**SOLICITATION AMENDMENT
JOC Contract No. 2019011
DORFP #6
CITY OF BUCKEYE**

AMENDMENT NO. 1

**SOLICITATION: JOC Contract No. 2019011 DORFP No. 6 – Delivery Order Request for Proposal
Sundance Water Campus Expansion**

Site Map

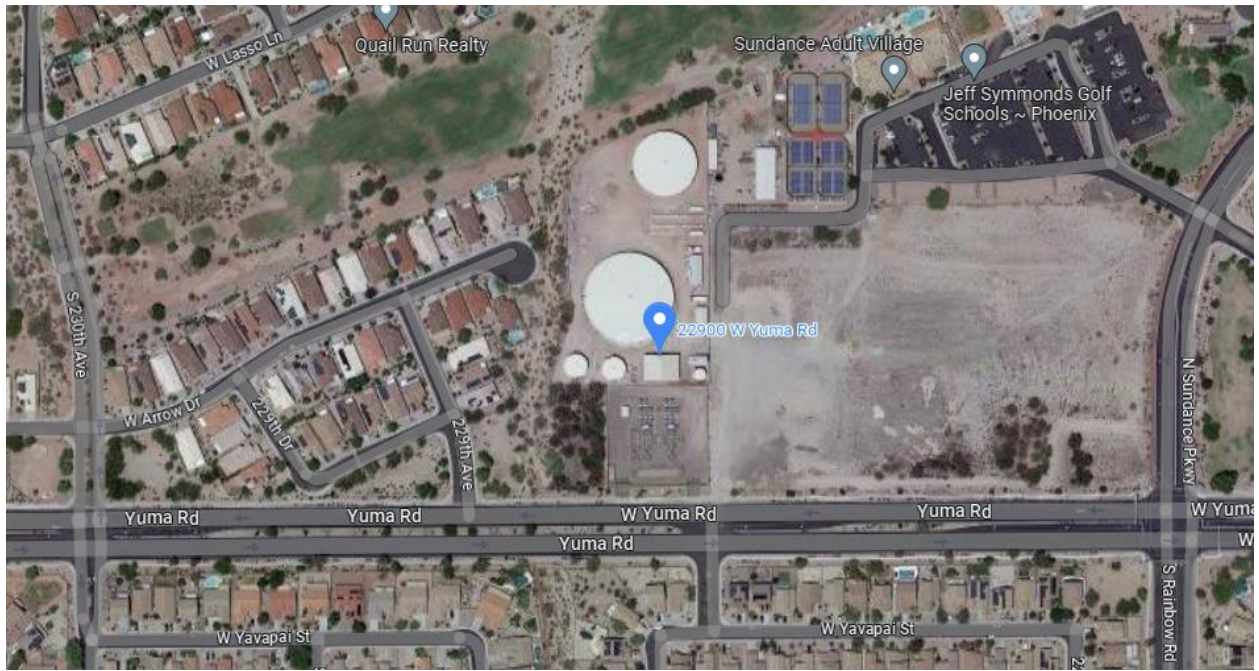
Exhibit C – Scope of Work and Site Maps: Scope of Work has been revised to remove the following items:

Onsite offloading and storage of new arsenic vessels and media

SCADA Programming

Potential Discharge Location of Effluent and Backwash Water During Commissioning of Filters

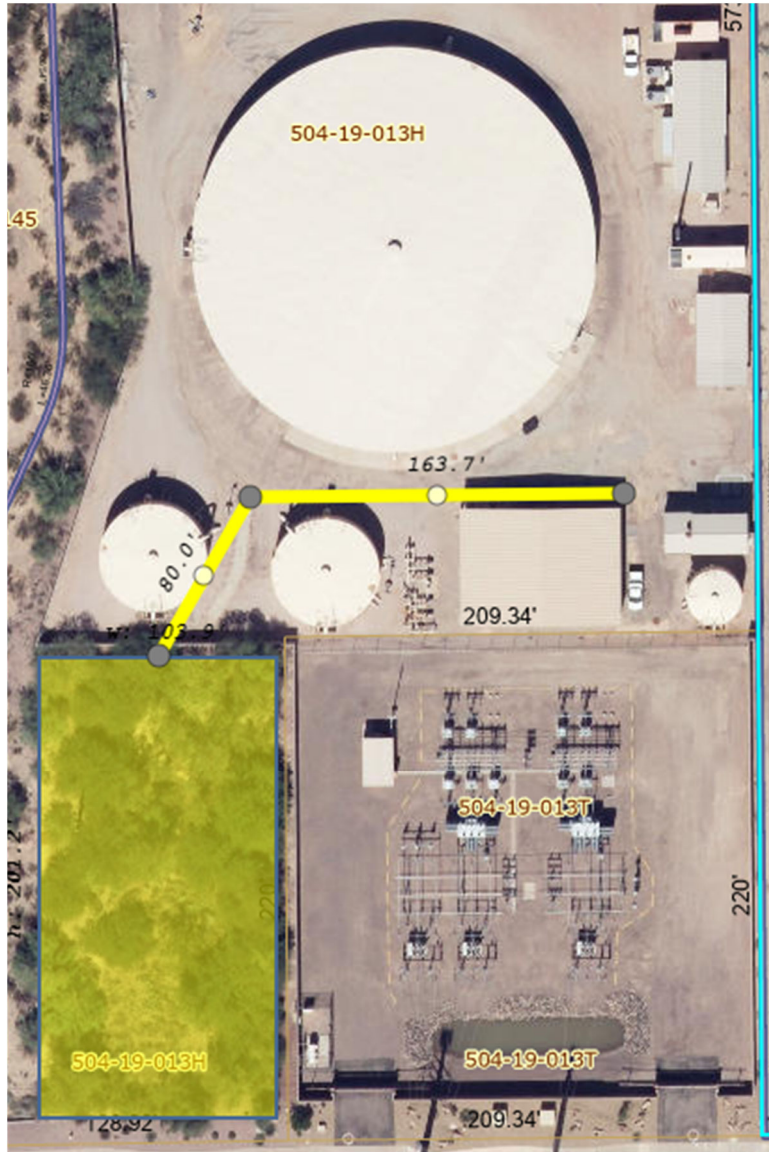
Q4. Where will the effluent water and backwash water go during commissioning?

A4. See Exhibit F.
